Palo Verde Nuclear  
Generating Station

**Subject: Palo Verde Nuclear Generating Station (PVNGS)  
Units 1, 2, and 3  
Docket Nos. STN 50-528, 50-529, and 50-530  
Response to Request for Additional Information Regarding License  
Amendment Request to Revise the Feedwater Line Break with Loss  
of Offsite Power and Single Failure Analysis (TAC NOS. ME4596,  
ME4597, and ME4598)**

**Response to Request for Additional Information (RAI) Regarding  
License Amendment Request (LAR) to Revise the Feedwater Line  
Break with Loss of Offsite Power and Single Failure Analysis  
(FWLB/LOP/SF)**

**Figure 1. Description of Time Points**

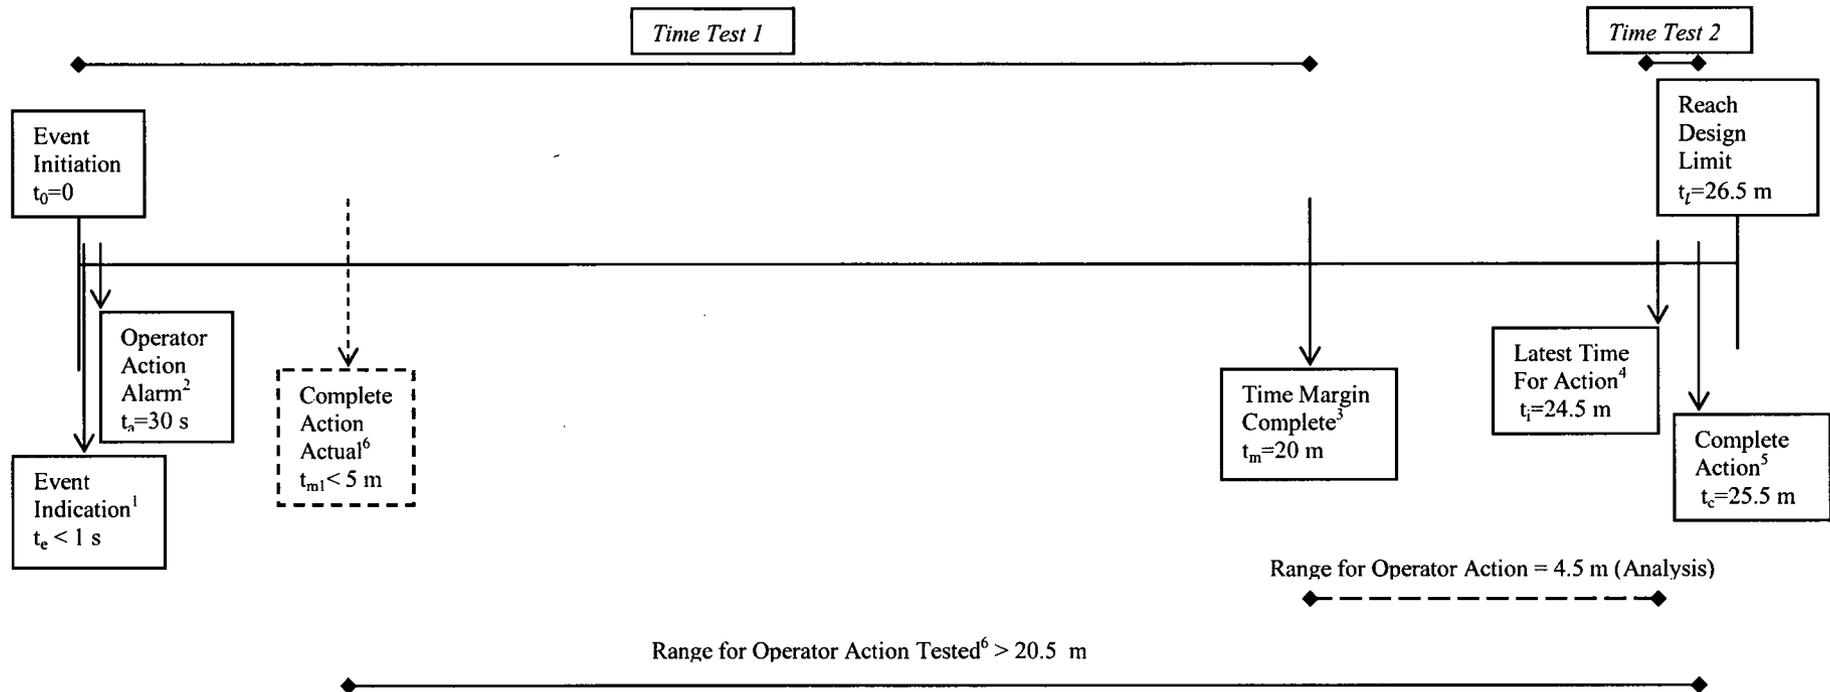
Please provide an evaluation to show that the 20 minutes includes the time allowed for indication and recognition, diagnosis, operator action, and system response. Include all documentation required by American National Standards Institute/American Nuclear Society (ANSI/ANS)-58.8, 'Time Response Design Criteria for Nuclear Safety Related Operator Actions' (i. e., the required operator action and the manipulations that make up the action, the indications that prompt the operator(s), and the feedback by which the operator verifies that the action succeeded or failed). Also, please provide event analysis chart(s) showing the assumed time interval estimates including time to indication, time to diagnose, time to complete the action, process time until success or failure would be recognized, and safety margin assumed, if any. Information provided in response to this request for additional information should provide evidence that PVNGS operators are highly likely (95 percent confidence or higher) to be capable of performing

Please provide any available empirical human performance data, such as timed simulator training scenarios, that are available to derive time intervals that could justify crediting the 20-minute assumption. The NRC staff notes that, in accordance with ANSI/ANS-58.8, such empirical evaluation should be designed to yield results at a 95 percent confidence level. Information provided in response to this request for additional information should provide evidence that PVNGS operators are highly likely (95 percent confidence or higher) to be capable of performing the required actions in the expected control room environment within the assumed time constraints of the analysis.

The timing of the operator action was selected based on the guidance and requirements of ANSI/ANS-58.8-1984. The data and selected Time Test Values (TTV), demonstrating a 95 percent confidence level, that are provided and justified in the ANSI/ANS-58.8-1984, Appendix, were also used. The application of criteria defined in Section 6 of the standard was utilized to evaluate the nuclear safety related automatic and manual actions, and associated time. Figure 1 (page 8) illustrates the discrete time points for the event. The following sections provide the details of the evaluation performed for FWLB, and describe the discrete time points provided in Figure 1:

The assumed 20-minute action time in the PVNGS analysis meets the requirements of ANSI/ANS-58.8-1984 for time allowed for indication, recognition, diagnosis, and planning of actions. Using the 20-minute action time plus the two minutes allowed for the operator action time delay and the equipment and process time delay, there is an additional "Range for Operator Action" margin ( $t_c - t_m$ ) of at least 4.5 minutes.

During a FWLB event, the opening of an ADV is a backup response to the automatic safety related function of the MSSVs. As a result, the identification of this ADV action does not require complete diagnosis of the FWLB event. The action of opening the ADV is identified and performed per the Standard Post Trip Actions EOP, prior to entering the event specific EOP. Thus, the 20 minutes allowed by ANSI/ANS-58.8-1984 for indication, recognition, diagnosis, and planning of the action, is conservative.

As discussed in the APS response to NRC Request # 6 below, the actual observed time of action in the simulator scenarios performed were all less than five minutes from FWLB event initiation until the ADVs were opened. As shown in Figure 1, using less than five minutes as the "Complete Action Actual ( $t_{m1}$ )," the time margin tested for the range for operator action ( $t_c - t_{m1}$ ) would be more than 20.5 minutes.

1. Trip of feedwater pumps on overspeed due to the break in the feedwater line. Also, in a very short time (2-3 seconds) alarms on the containment conditions.
2. MSSV opening alerting operators to open ADV to prevent cycling of MSSVs
3. Time Test 1: Time Margin (20 min) determined by ANSI/ANS-58.8-1984 for a limiting fault event (includes Time Test 2, Fixed Portion, in accordance with the Section 5.4 of the Standard)
4. Time Test 2, Variable Portion: Time (1 min) determined by ANSI/ANS-58.8-1984 (vs. actual 20-30 seconds operator action time delay)
5. One minute assumed conservatively although the operators will have indication that action is successful (e.g., decreasing SG pressure within 10-20 seconds)
6. Based on the Simulator verification performed by three different operation crew (see APS Response to Question 6)
